SAN ONOFRE UNITS 2 AND 3

RESPONSE TO NRC QUESTION 221.19

APRIL 25, 1979

COMBUSTION ENGINEERING, INC.
NUCLEAR POWER SYSTEMS
POWER SYSTEMS GROUP
WINDSOR, CONNECTICUT

Figure 1.

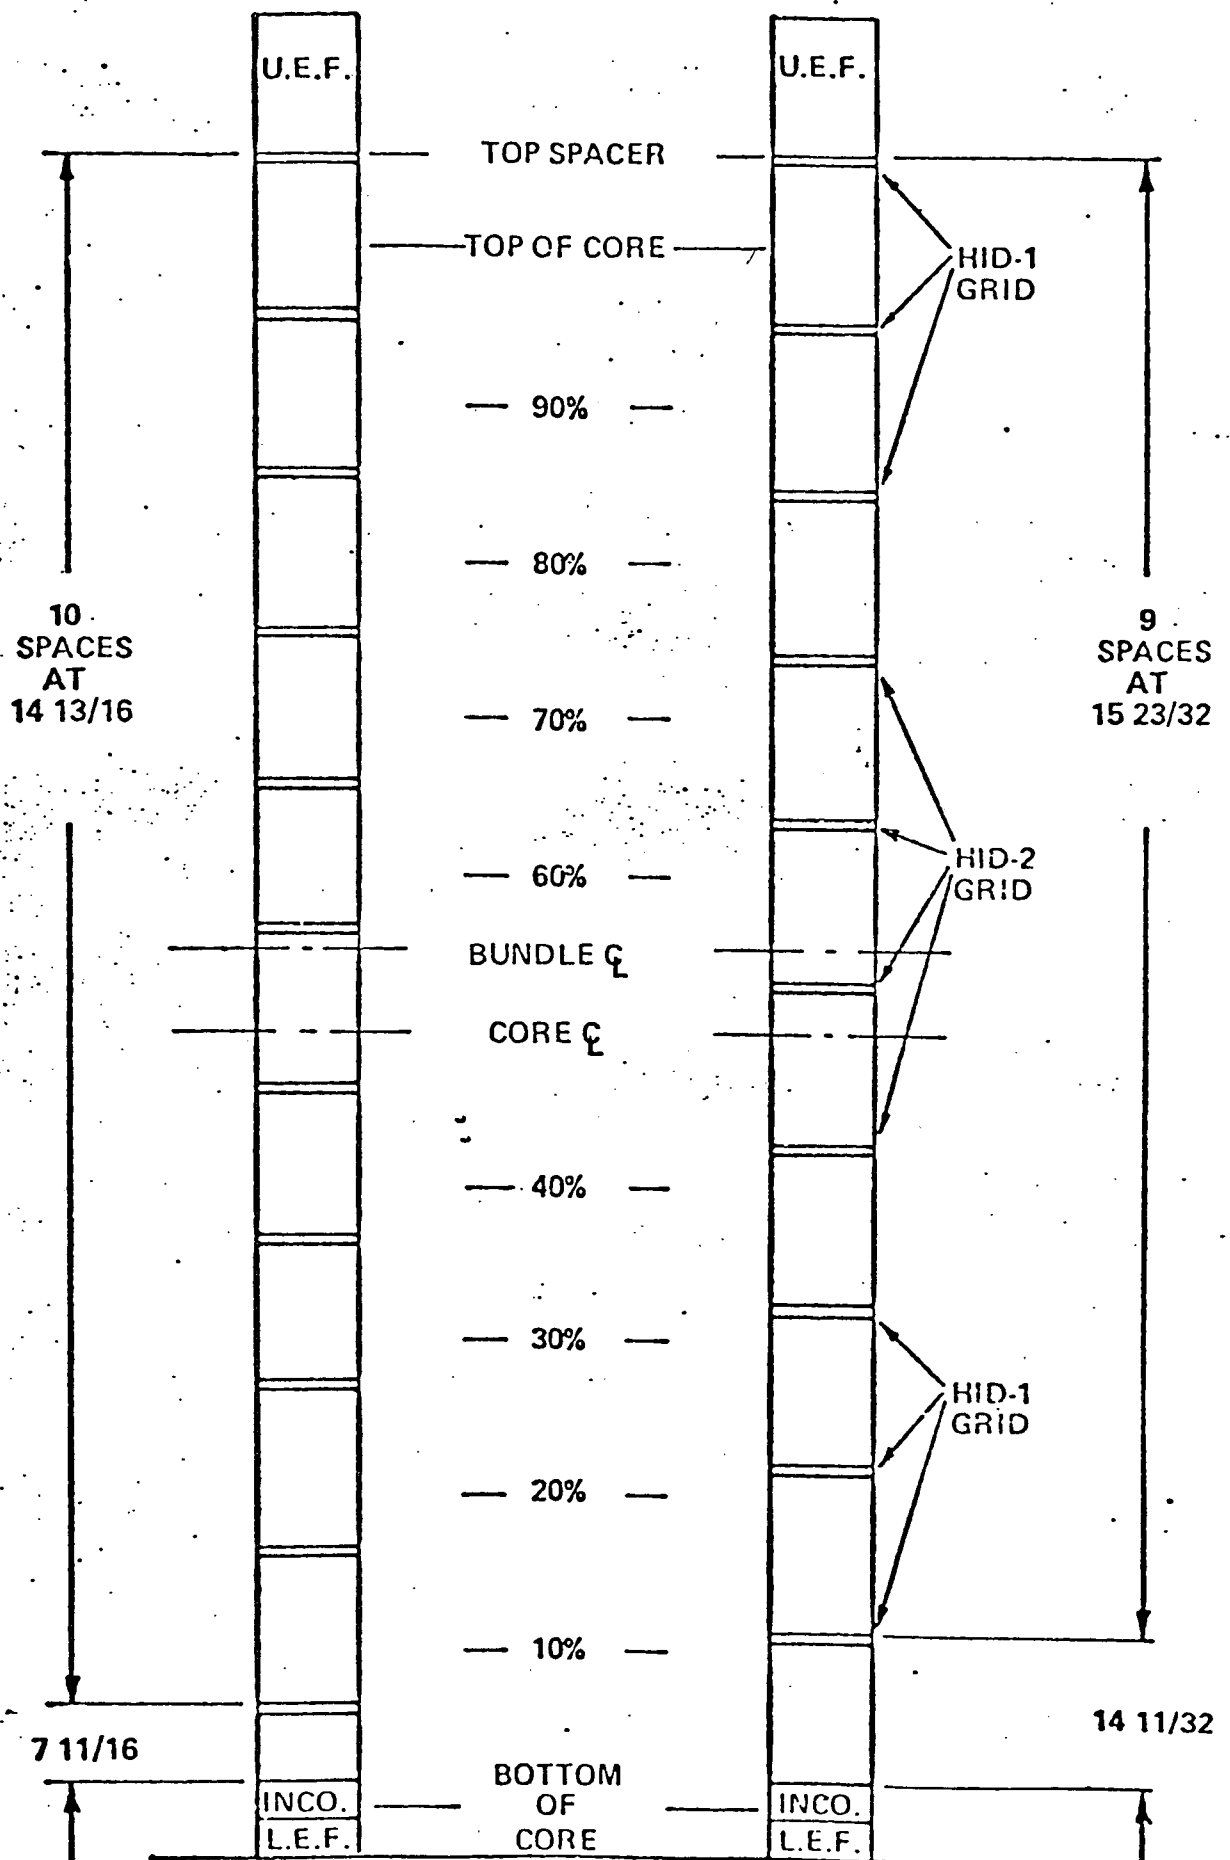
It is our understanding that San Onofre 2 and 3 will use fuel assemblies with support grids which are thicker and higher than comparable grids for the 16x16 fuel design in ANO-2. Also the grid spacing has been increased relative to the grid spacing for ANO-2 by using one less grid for the bundle. The new San Onofre 2/3 fuel design is not presently described in the FSAR. The effect of these changes in grid design may be to reduce the critical heat flux for San Onofre fuel relative to that for ANO-2 and other plants which use the same grid design as ANO-2. Therefore, provide data to justify the use of the CE-1 CHF correlation for San Onofre or propose another, acceptable, correlation for use on San Onofre 2 and 3.

[The spacer grid positions for Arkansas and San Onofre 2 & 3 fuel assemblies are shown in Figure 1.] 3,5

LATERAL GEOMETRY AND ROD POWER DISTRIBUTION

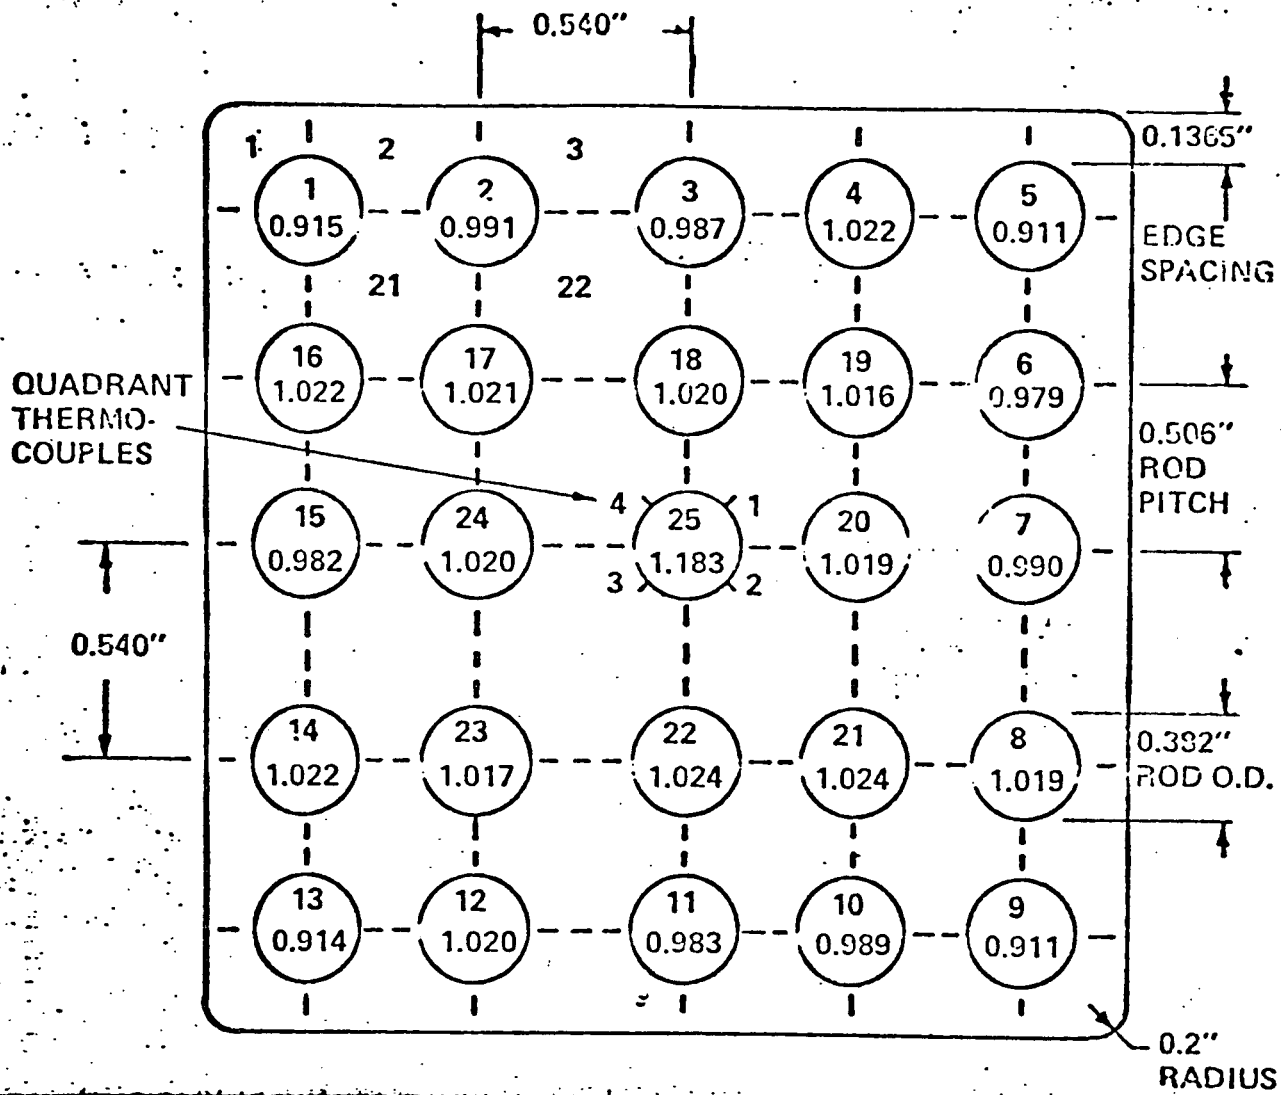
The test for the effects of bundle corners on CHF which have been discussed informally with CE and SCE are not appropriate to satisfy the data needed to justify the use of the CE-1 CHF correlation for San Onofre.

The test used an electrically heated 25 rod bundle simulating the corner region of four adjacent 16x16 fuel assemblies positioned such that the gap between them would be a minimum (see Figure 3). The test section had a 7' uniformly heated length and a nonuniform lateral power distribution as shown in Figure 3. A typical spacer grid is shown in Figure 4; the test grid geometry is identical to that of the HID-1 spacer grids which will be
